RE: PROPOSED 4 SINGLE HOUSE (THREE STOREYS) ON LOT 1 (62) ROBINSON AVENUE, PERTH

We refer to the above development application and the subsequent City's letter dated 28 May 2015, requesting additional information to be provided in the form of written justification and/or amended plans. Planning Design Group (PDG) acts on behalf of SUMMIT PROJECTS with respect to this planning application for approval to develop 4 Single House (Three Storeys) on **Lot 1 (62) Robinson Avenue, Perth** (subject site).

RE: **PROPOSED 4 SINGLE HOUSE (THREE STOREYS) ON LOT 1 (62) ROBINSON AVENUE, PERTH**

We refer to the application regarding the above mentioned development and the subsequent City's email dated 27 July 2015, requesting additional information be provided in the form of written justification and/or amended plans.

Figure 3 - Existing streetscape character at Brisbane Terrace

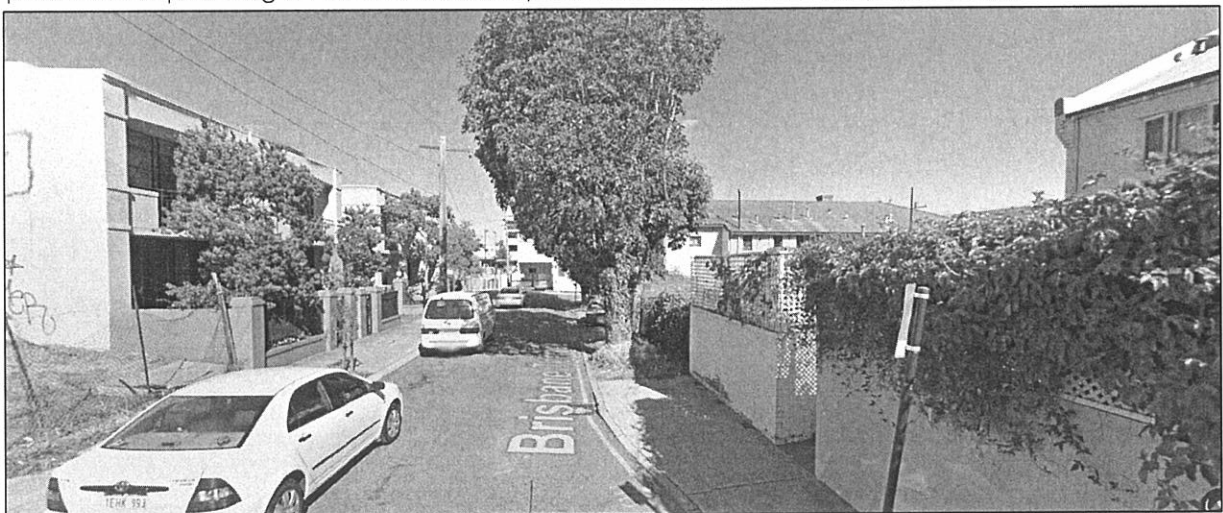
The proposed design of the dwellings have concealed flat roof which a crucial design element of the contemporary concept in lieu of required pitch roof (30-45 degrees).

The proposed flat roof actually improves the amenity of the adjoining properties in terms of reducing the overall building bulk and overshadowing cast onto the adjoining property. The proposed roof form design is also considered to compatible with the existing development (1/2 Brisbane Terrace) which is located directly across Brisbane Terrace from the development site. Refer to above **Figure 3**.

Figure 1 – Existing front solid street fence of adjoining property – 64A Robinson Ave.

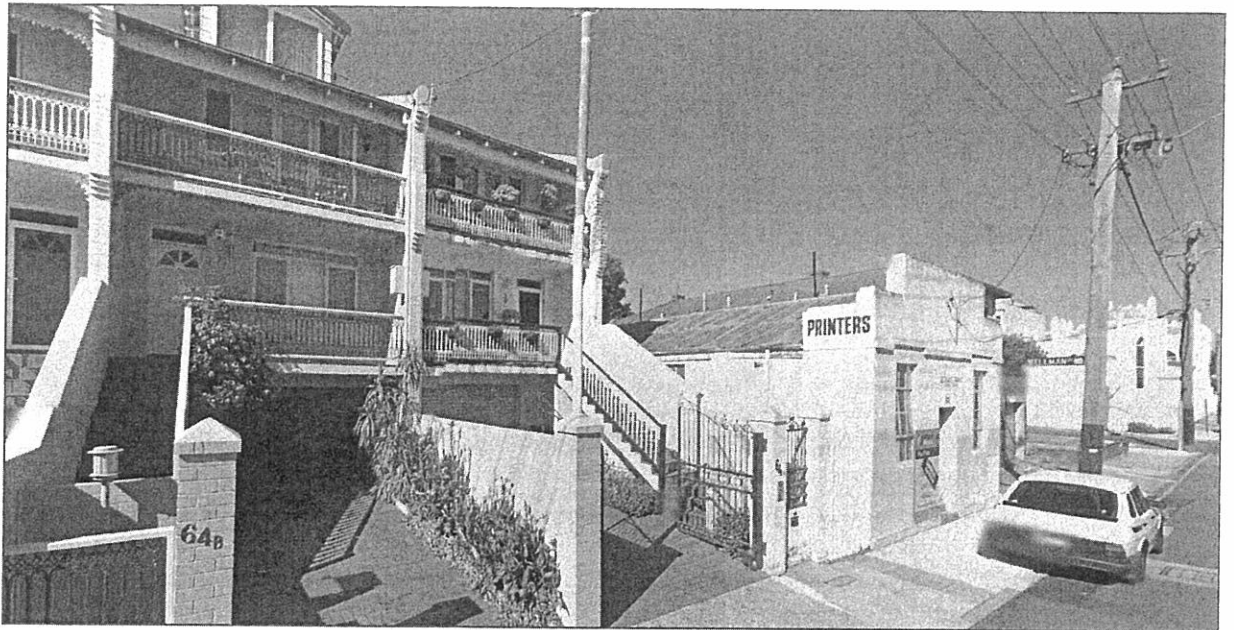
2. Visual truncations are required to be provided within 1.5m of vehicle access points.

Based on the feature survey and street view provided, there are existing permanent structures on the boundary fence of adjoining properties which are outside the development site legal boundary. No solid structures are proposed within the visual truncation area of the development site. See site photos below showing existing solid front fence of adjoining properties.

Nevertheless, the driveway is setback at least 0.75m from the side boundary where it meets with the street boundary, providing a degree of unobstructed sight lines.
